Addendum

PROJECT:
New Administration Building Renovation
3103 Ave. G
Hondo, Texas 78861

ADDENDUM NO.: 2

DATE OF ISSUANCE: September 3, 2024

9 TLTRM 146
1/2" = 1'-0"

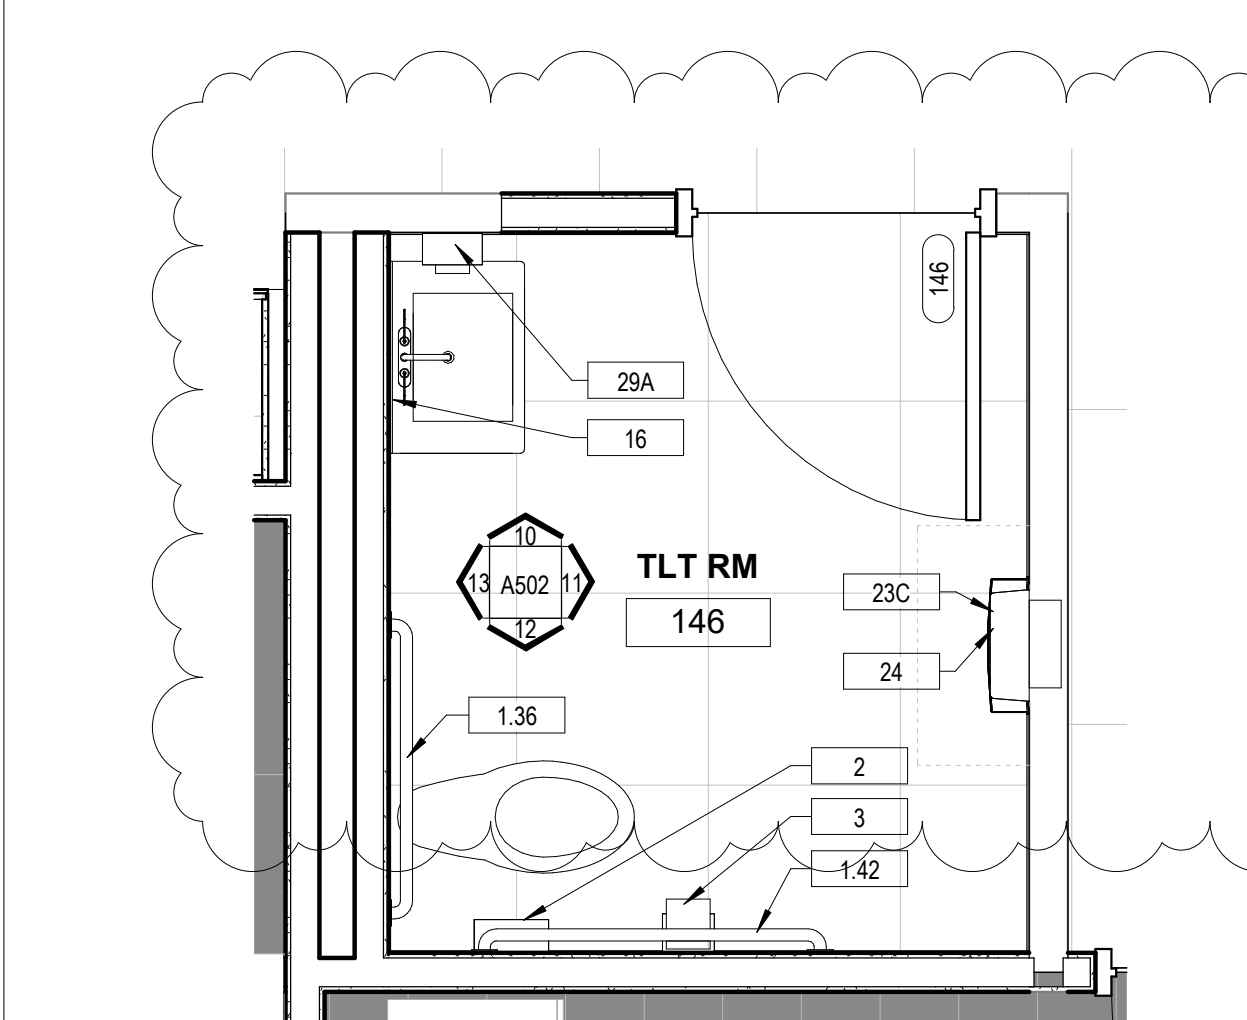
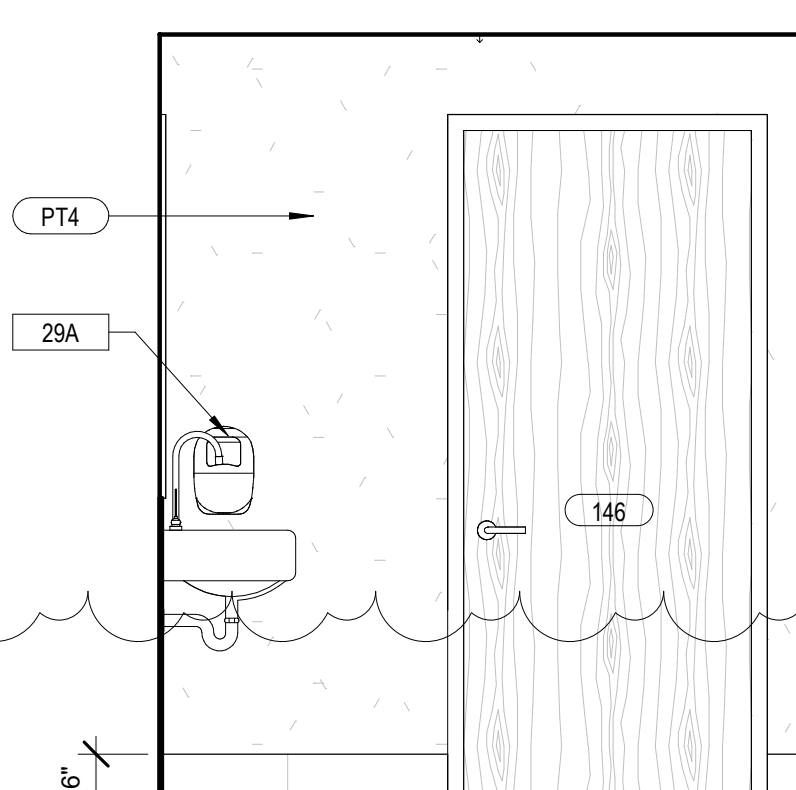
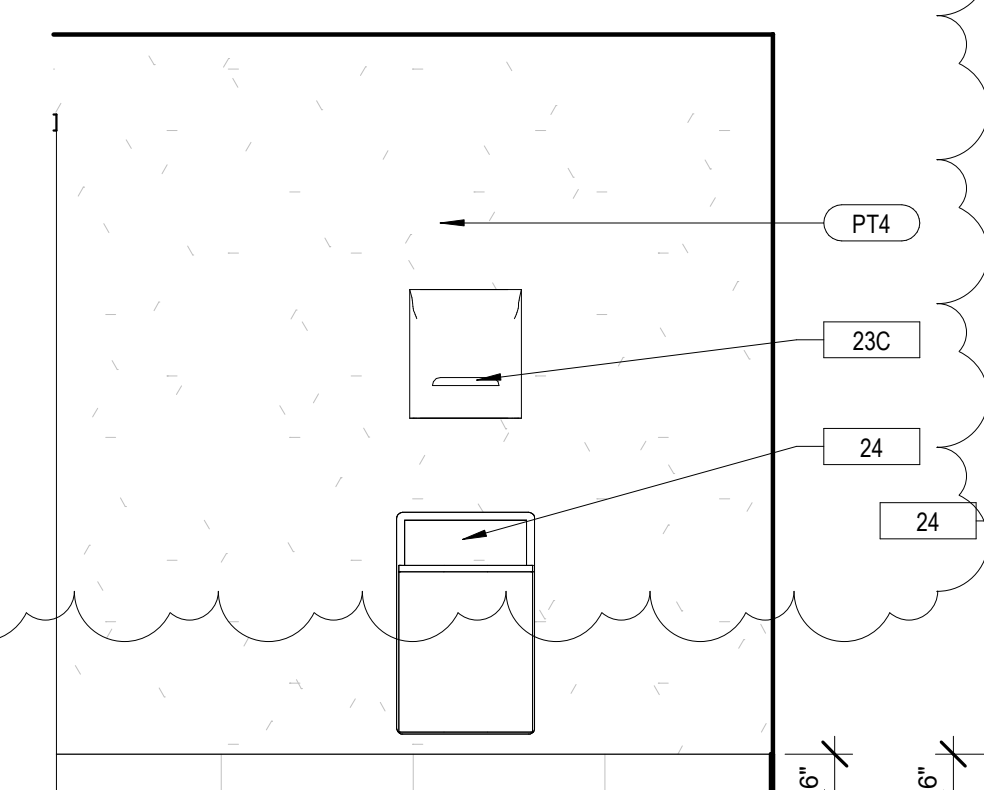
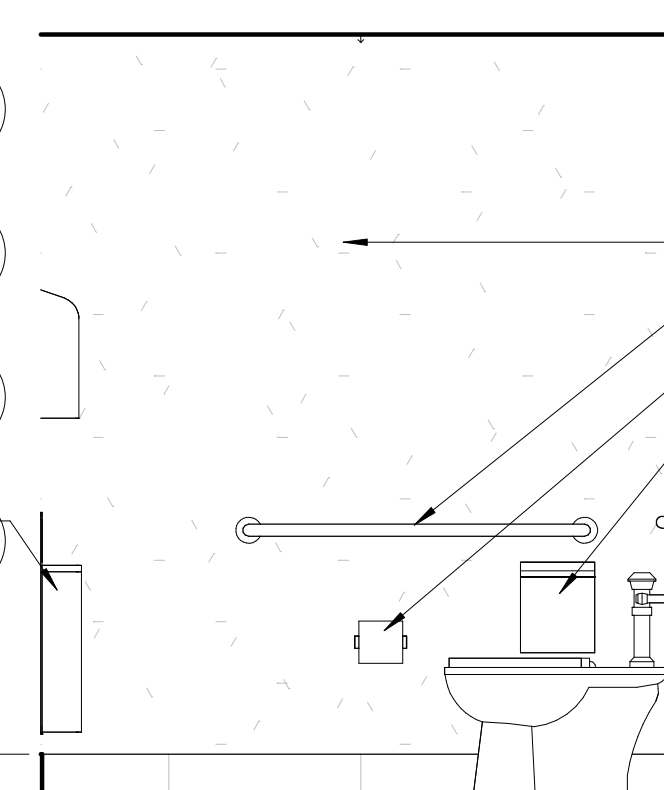
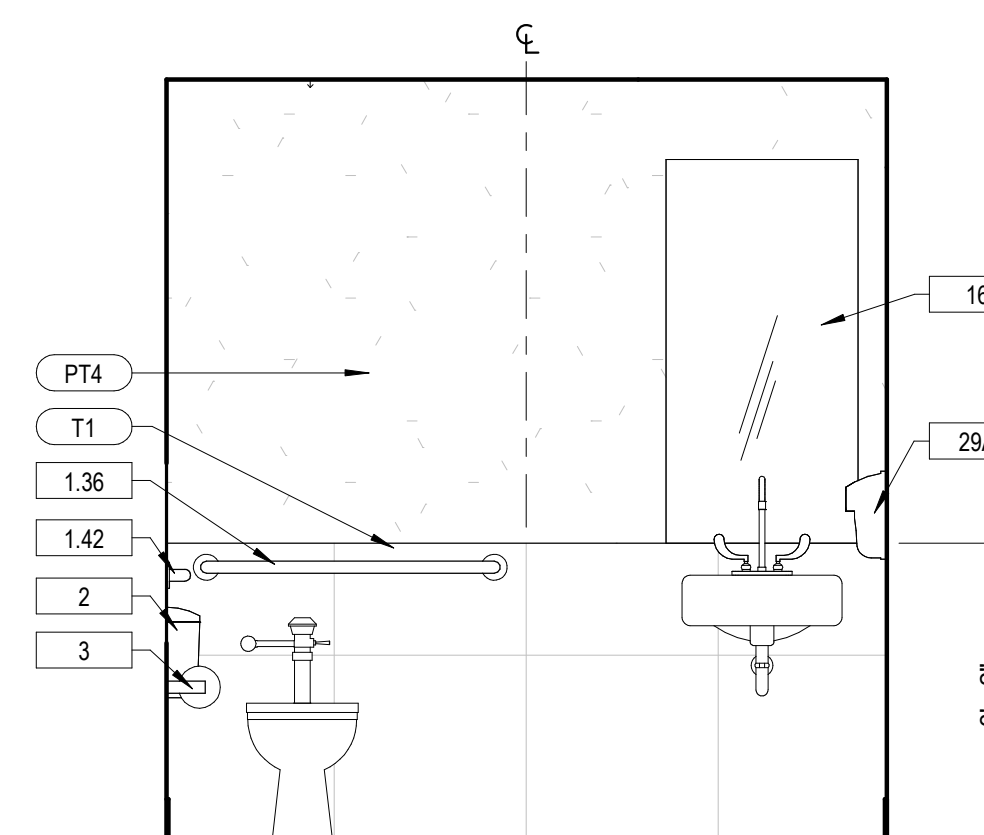
- Accessibility: Ensure compliance with reach ranges and parking dimensions and signage (painted and mounted per TAS and reference sheet G102 – no attachment).
- Architectural: Adjust location of paper towel dispenser in Room 146 (see attached plans).
- MEP: Adjust transfer duct locations; revise drain and water supply locations; add new lighting at exterior canopy; add power for parapet signage; and add light fixture type (see attached narrative and plans).

MECHANICAL - FLOOR PLANS - LEVEL 01

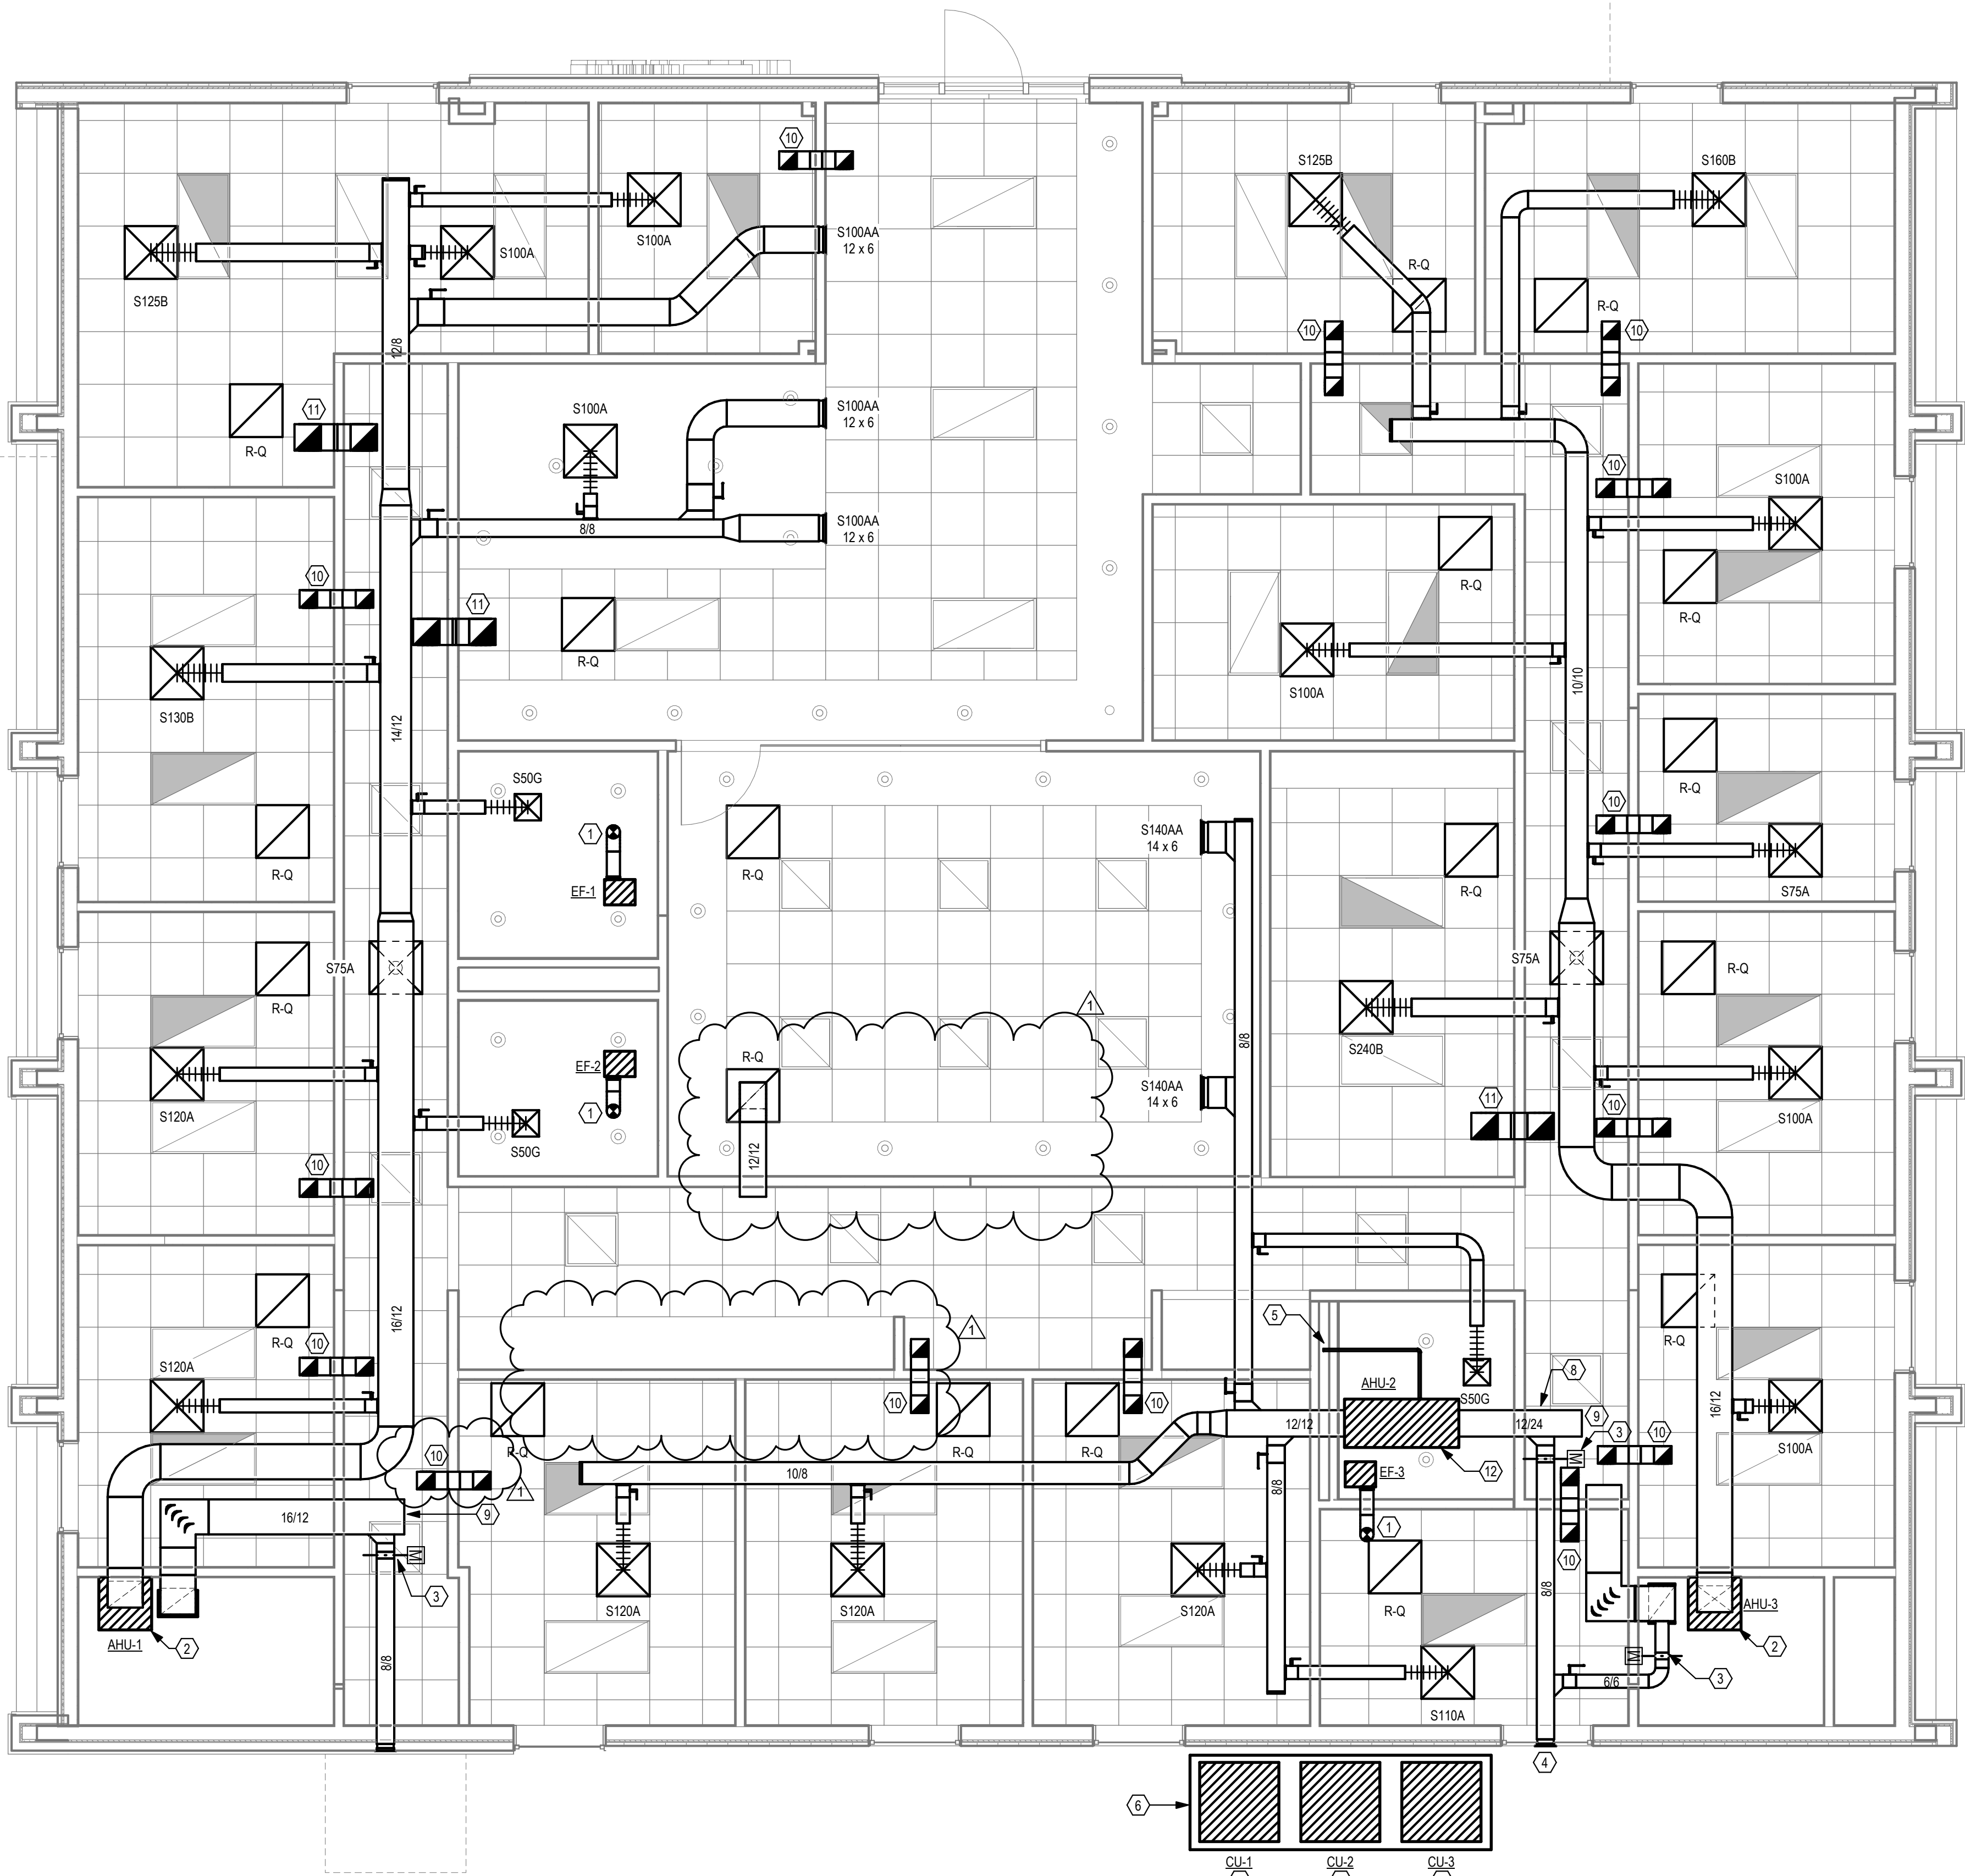
Item	Reference/Description
1.	M-101 – Mechanical – Floor Plans – Level 01 Item 01 – Adjust the transfer ducts in the Conference Room and Copy Area per attached Mechanical Sheet M-101.
2.	P1.1 – Plumbing Sanitary Sewer and Vent Floor Plan Item 01 – Revise the drain and supply lines per attached Plumbing Sheet P1.1.
3.	E101 - Floor Plan - Lighting Item 01 – Add new lighting at the exterior canopy per attached Electrical Sheet E101.
4.	E201 - Floor Plan - Power Item 01 - Add power for new exterior signage per attached Electrical Sheet E201.
5.	E301 - Electrical Symbols and Abbreviations Item 01 - Add Lighting Fixture Type 'D' to the Lighting Fixture Schedule per attached Electrical Sheet E301.
